HIROSE ELECTRIC CO., LTD.
5-23, OSAKI 5-CHOME, SHINAGAWA-KU, TOKYO, JAPAN

Product Change Notification

■ Product list: Business430-17021_DF60 Series Crimping socket_Shape change of lock lever

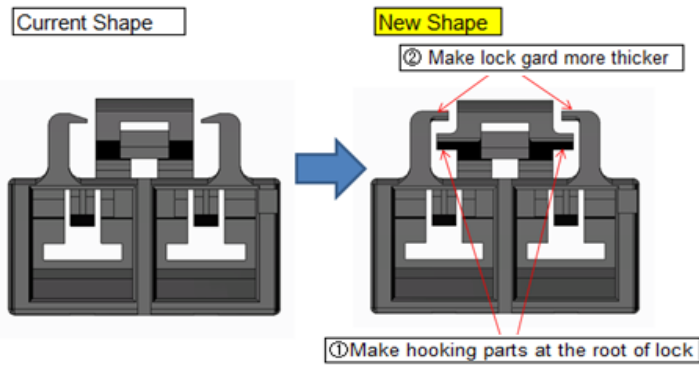
1	Products affected	DF60 Series crimping socket Please refer to the attached sheet on details.
2	Replacement products	Please refer to the attached sheet
3	Classification of change	Specification change
4	Description of change	<p>①This is to change the shape of lock lever. For 5 pin and 6 pin which originally have new shape, we will change product name only.</p>  <p>②This is to improve the strength of lock lever.</p> <p>These changes will not affect the performances of the products.</p>
5	Reason for change	For improving product performance(strength of lock lever)
6	Date of final reception of orders for the current product	August 31, 2018
7	Date of first reception of orders for the replacement	Already started selling
8	Date of final shipment of the current product	November 30, 2018
9	Date of your acknowledgement	By March 30, 2018
